CALIFORNIA COASTAL COMMISSION

Combined Staff Report: Two Appeals De Novo Hearing

Appeal NumbersA-3-PSB-06-002 and A-3-PSB-06-003

Project location.....188 Seacliff Drive, Pismo Beach (APN 010-505-014).

Exhibit 3: Proposed Site Plan

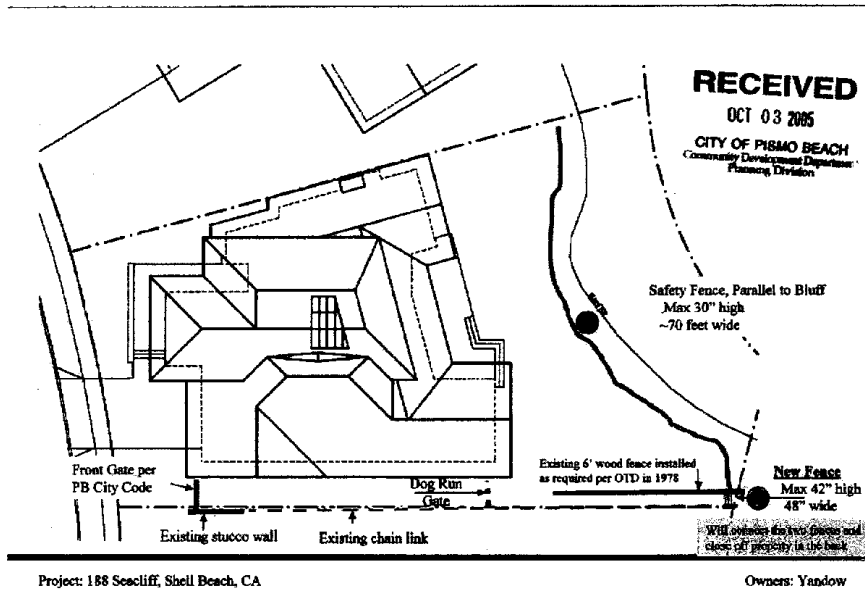
Similar to the impacts identified in the findings above, the proposed rear yard fencing has the potential to obstruct lateral and vertical access to the shore because the site plans submitted for the development are not adequate to allow staff to determine whether the new rear yard fencing encroaches within the path historically used for public access. The Coastal Act requires that maximum public access be provided in all new development (30210). The Act further prohibits development from interfering with the public's right to gain access to the sea (30211) and

requires public access from the nearest roadway to the shore be provided in all new development (30212). As currently proposed, installation of the rear yard fencing may interfere with such access and therefore is not consistent with the Public Access policies of the Coastal Act. The project can be made to conform, however, to applicable Coastal Act and LCP policies with the imposition of special conditions that require the Applicant to remove and relocate any development that encroaches within the path used for public access to the shoreline. Such conditions are necessary to ensure that public lateral and vertical access will be preserved and that the approved development will not interfere with the public's right to gain access to the sea. Special Condition 1 limits the northern extent of the proposed rear yard fencing to no further upcoast than the alignment of the existing wood fence as shown in Exhibit 4. Special Condition 2 expressly prohibits any development within the area used for public access and further requires the applicant to prepare a legal description of the access path to be recorded along with a deed restriction.

Exhibit 4: Revised Site Plan per Special Condition 1
Application Nos. A-3-PSB-06-002
and A-3-PSB-06-003
Yadow Fence Appeals

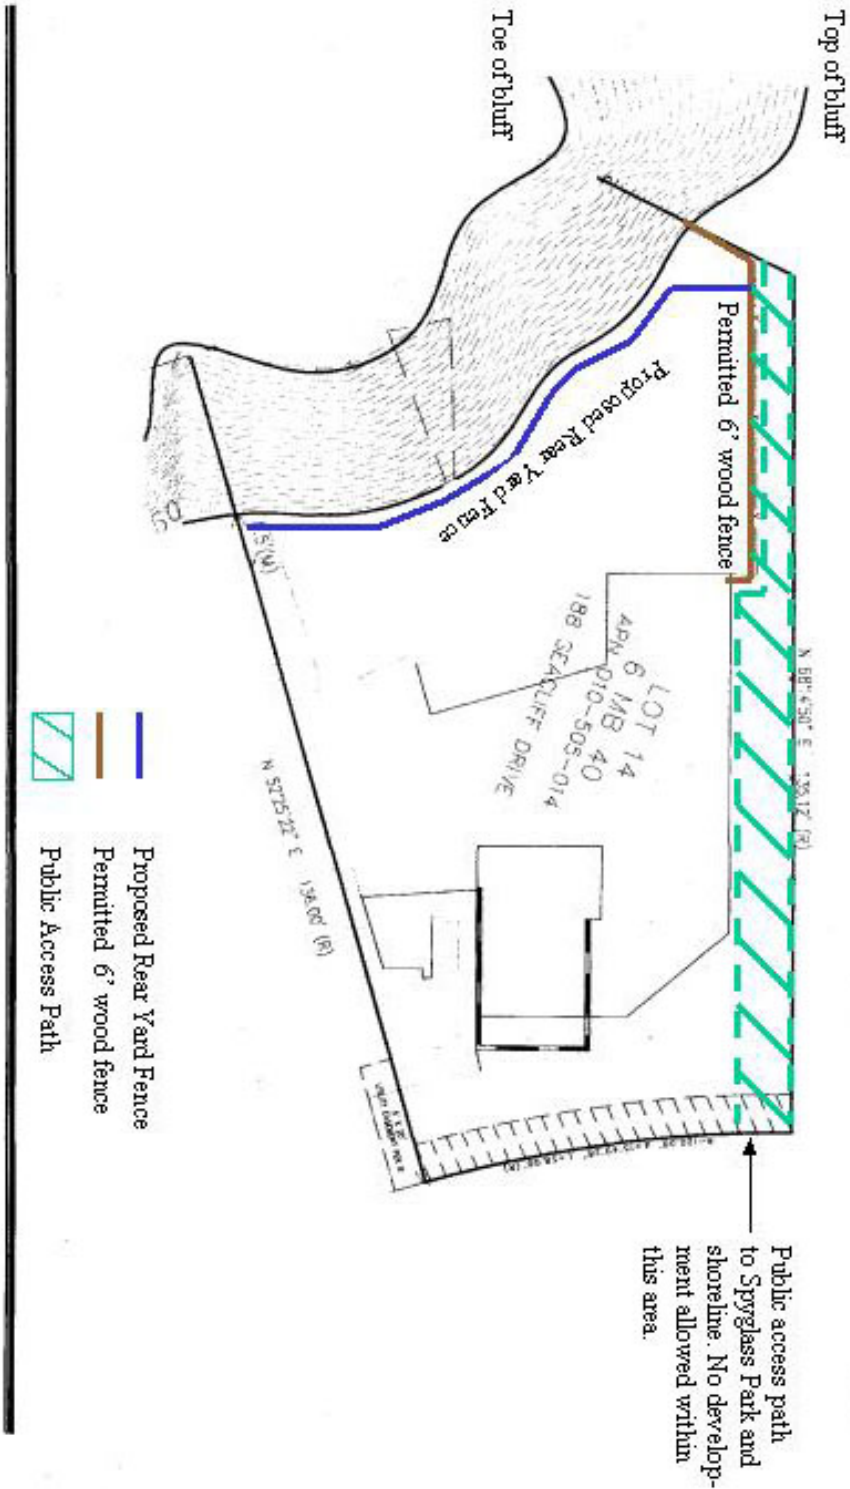
- a. Location and Alignment. The location of the rear yard fencing shall be setback a minimum of 6 feet from the bluff edge and not extend any further upcoast than the alignment of the existing wood fence as shown in Exhibit 4. The final site plan illustrating this alignment shall identify property lines, the existing wood fence in the northwest corner of the site, and the existing residence as reference points.
- b. Height and Materials. Fencing shall be a maximum of 30 inches in height and made of wrought iron or similar “see-through” material. Fencing shall be secured with ¾” rebar posts driven into the ground. In order to facilitate relocation of the fencing in response to erosion events and maintain a continuous 6’ setback from the bluff edge, concrete or similar materials shall not be used to found the fence or fence posts.

- a. No development, as defined in section 30106 of the Coastal Act, shall be allowed in the area used for public access as generally depicted in Exhibit 4, and as described and depicted in an Exhibit attached to the Notice of Intent to Issue Permit (NOI) that the Executive Director issues for this permit, except for development designed to protect and enhance public access to and along the shoreline, including but not limited to pathway improvements, access signing, etc.
- b. PRIOR TO ISSUANCE BY THE EXECUTIVE DIRECTOR OF THE NOI OF THIS PERMIT, the Applicant shall submit for review and approval of the Executive Director, and upon such approval, for attachment as an Exhibit to the NOI, a formal legal description and graphic depiction of the portion of the subject property used for public access, as generally described and shown on Exhibit 4 attached to this staff report.
